Underwriters Laboratories Inc.®

Revision pages for

Air Filter Units

UL 900, Sixth Edition

Figure 5.1
Flame exposure test apparatus

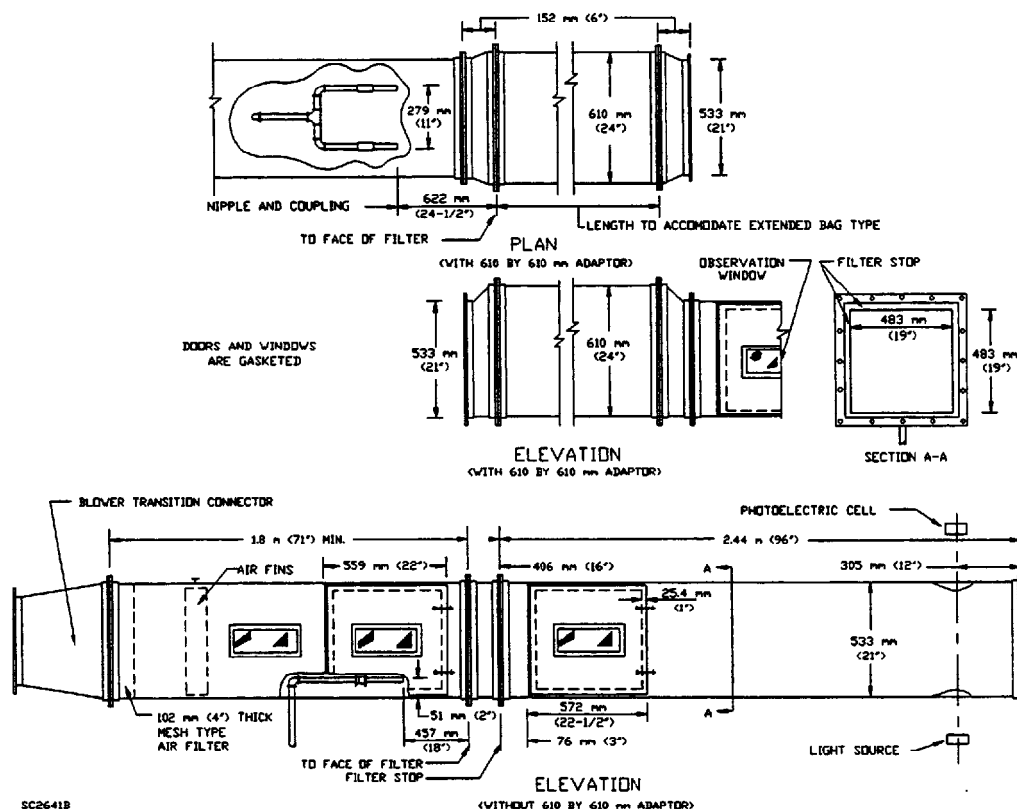
Figure 5.1 revised April 5, 1996
